CERTIFICATE OF APPROPRIATENESS

Property: 625 Cortlandt Street, lot 6, tracts 5 & 7A, block 278, Houston Heights Subdivision. The property includes a historic 1,649 square foot, one-story wood frame single-family residence and a detached garage situated on a 10,560 square foot (80' x 132') interior lot.

Proposal: Alteration – Revision

A COA for the addition of dormers to the residence was partially approved in March 2015 with the following requirements: Approval of the rear dormer; Denial of the front dormer. This application includes the following revisions:

NORTH SIDE ELEVATION

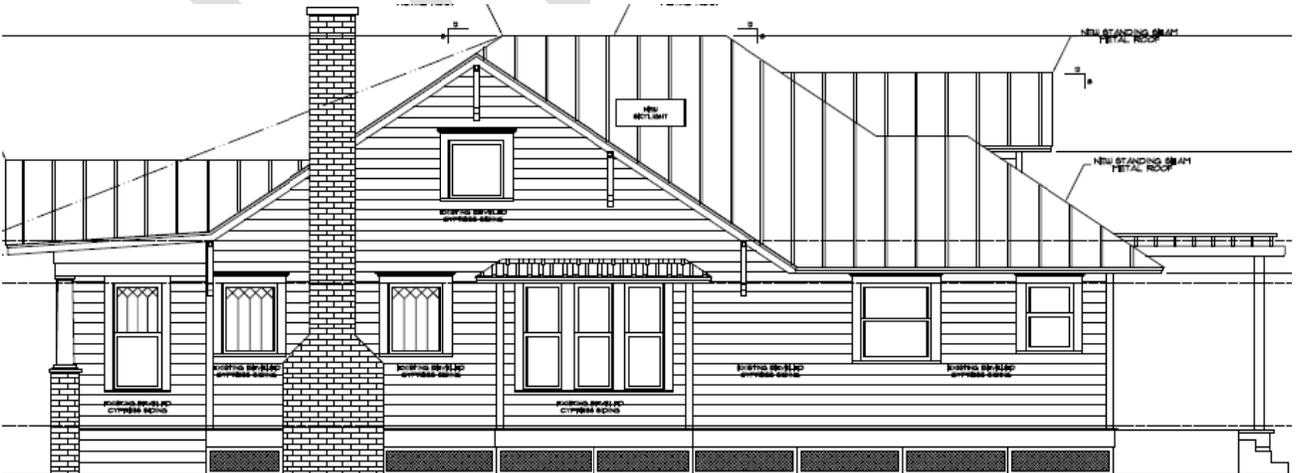
Side Elevation: The residence features eight windows at the first floor and a chimney to remain. One window in the gable will be removed and replaced by a larger window.
(North)

WEST (REAR) ELEVATION

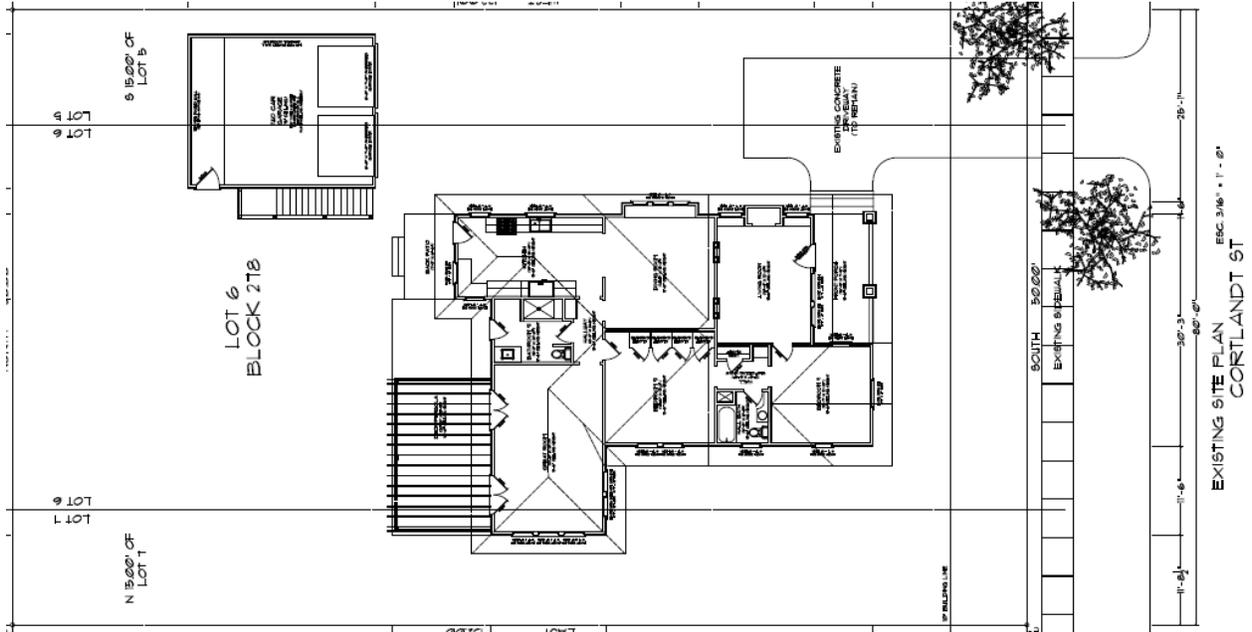
- No front dormer is proposed
- The rear dormer will be increased in width from 6'-11" to 11'-1"
- Four skylights will be installed
- One window in the north side gable and one window in the south side gable will be removed and replaced with larger windows

Rear Elevation: Not visible from public right of way. See elevation drawings for details.
(West)

ROOF PLAN

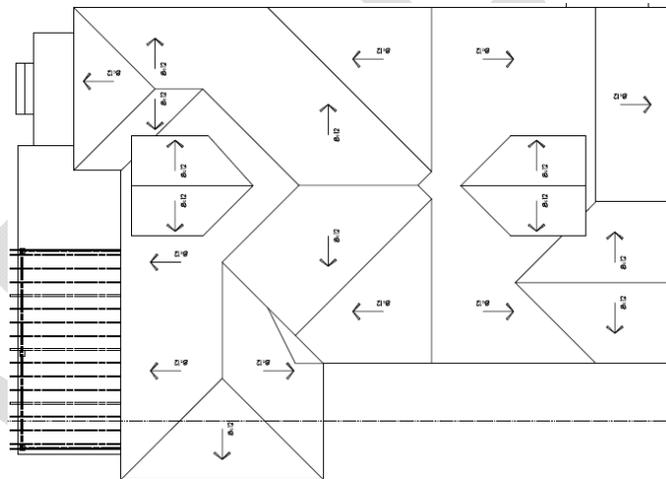
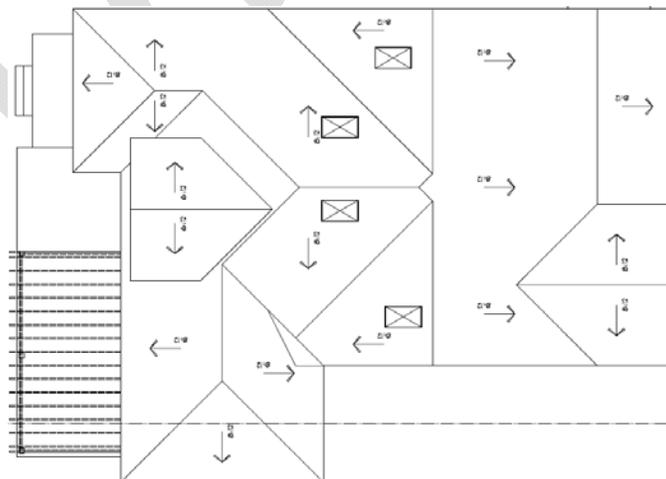
Roof: The residence feature a side gable roof with a rear hip and a small gable projecting to the east, all with an 8/12 pitch clad in composition shingles. The composition shingles will be removed and replaced with standing seam metal and a rear dormer will be installed. Four skylights will be installed, two behind the main ridge facing west and two on the rear hip, one facing north and one facing south.

NORTH GABLE WINDOW DETAILS

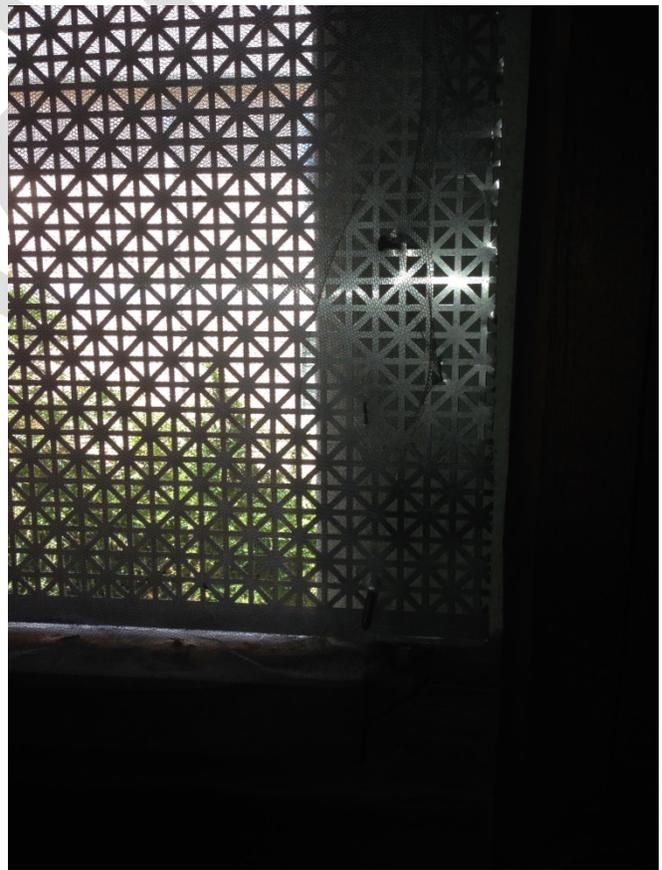
Windows/Doors: The residence features double hung wood windows and a wood front door to remain. One non-original fixed wood window on the north gable (currently missing glass) will be removed and replaced by a larger window measuring 2'-6" wide by 3' tall within a 35" wide original opening. One fixed wood window on the south gable will be removed and replaced by a larger window measuring 3'-6" wide by 3' tall within a 38" wide original opening. Existing trim on both windows is cementitious and will be replaced in kind. Four skylights measuring 24" wide by 36" tall will be installed.

**SOUTH GABLE WINDOW DETAILS
TO BE REPLACED**

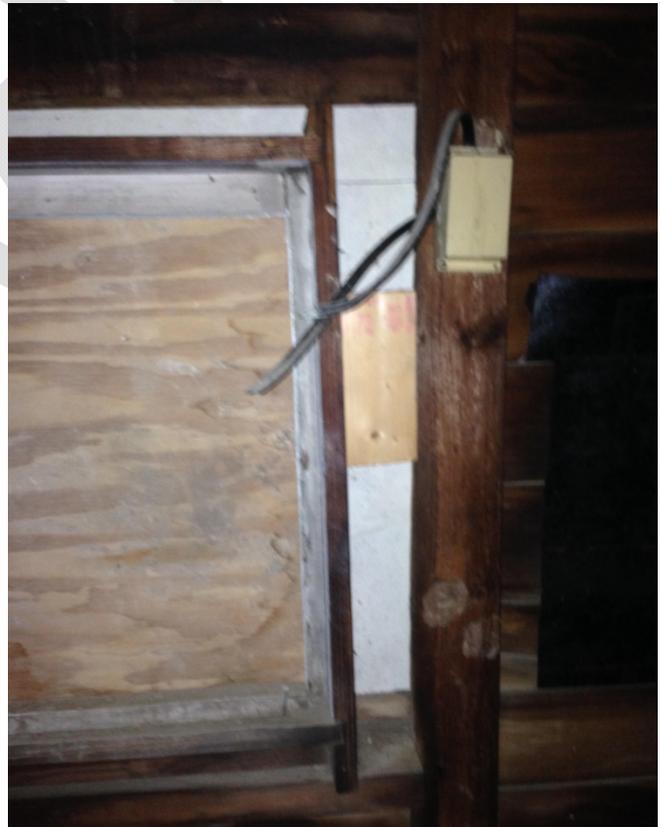
Side Elevation: The residence features seven windows on the first floor to remain. One window in the gable will be removed and replaced by a larger window.
(South)
